Wadsworth Boulevard Widening Value Engineering Study Report

City of Wheat Ridge Public Works

The 3.5-day Value Engineering Workshop was held from April 30th to May 3rd, 2018 at City of Wheat Ridge City Hall located at 7500 W 29th Ave, Wheat Ridge, CO 80033. The VE Study was undertaken in accordance with the Colorado Department of Transportation (CDOT) Value Engineering Guidelines as well as the SAVE International Value Engineering Job Plan, which includes three stages: (1) Pre-Workshop, (2) Workshop, and (3) Post-Workshop.

| DESIGN COMMENT DC-23 | |
|--|--|
| DESCRIPTION OF DESIGN COMMENT: Revise the driveway to Walgreens to a right-in only | Page No. 1 of 1 Prepared By: Russ Higgins |

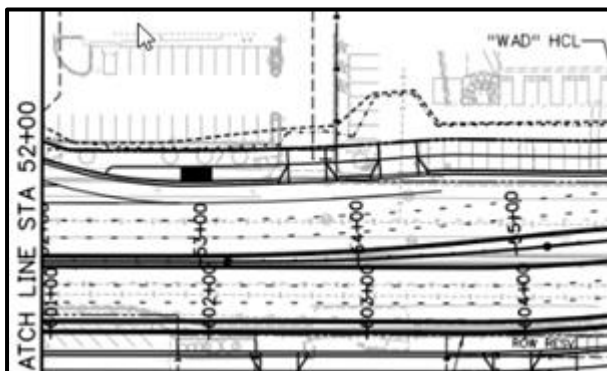
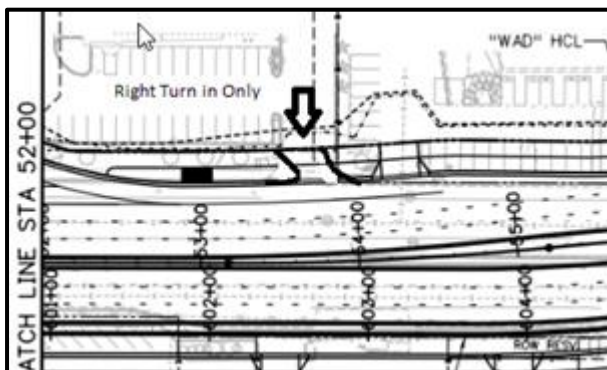
- The driveway would improve safety by limiting it to a right in only in the exclusive right turn lane.
